**COMMENTS OF THE
MANUFACTURERS OF EMISSION CONTROLS ASSOCIATION
ON THE U.S. ENVIRONMENTAL PROTECTION AGENCY'S DRAFT TECHNOLOGY
ASSESSMENT REPORT: MIDTERM EVALUATION OF LIGHT-DUTY VEHICLE
GREENHOUSE GAS EMISSION STANDARDS AND CORPORATE AVERAGE FUEL
ECONOMY STANDARDS FOR MODEL YEARS 2022-2025**

DOCKET ID NO. EPA-HQ-OAR-2015-0827

September 26, 2016

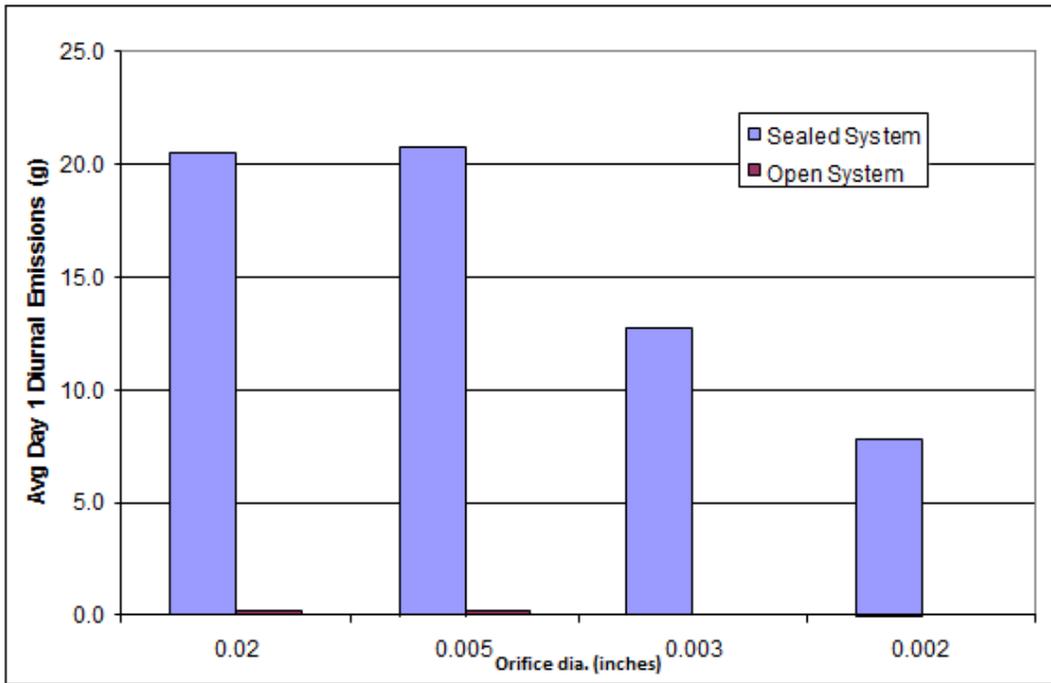
MECA members have modeled the level of puff emissions that may be expected in real-world operation. There are two major operating factors that affect the magnitude of puff losses. The fuel tank temperature at the time of cap removal and the amount of air in the fuel tank at refueling. Generally, as fuel tank temperatures increase, the puff losses increase. While the current California refueling procedures require a tank temperature of 26.7°C at the time of cap removal, this is by far not the worst case condition. In many parts of the country, including southern California, tank temperatures can easily reach 46-53°C following the running loss drive. This was documented in EPA’s 2014 tank temperature evaluation.¹⁰ The amount of air in the fuel tank at the time of refueling is also an important factor to puff emissions. Most NIRCOS tanks operate with a vacuum relief valve during parking conditions and can be vented to the atmosphere during driving. Ultimately, the amount of air vented is dependent upon the soak temperature prior to the running loss drive or whether the tank is vented during the running loss drive. Under running loss driving conditions, modeling shows that puff losses can reach 35-50 grams per refueling event. These emissions are half to two-thirds the level of uncontrolled refueling emissions. The issue is that the puff losses always occur prior to a refueling event, and during in-use conditions the canister can be preloaded with 35-50 grams of vapor before the canister functions to control the approximately 75 grams of refueling vapor during ORVR. In-use, the canister needs approximately 110-125 grams of capacity for full control of the puff and refueling event. On the other hand, during certification the canister is not preloaded with puff losses, so the canister only needs to control the approximately 75 grams of displaced refueling vapor. The certification conditions result in a technology package response of capacity only needed for controlling the 75 grams of refueling vapor and no puff losses.
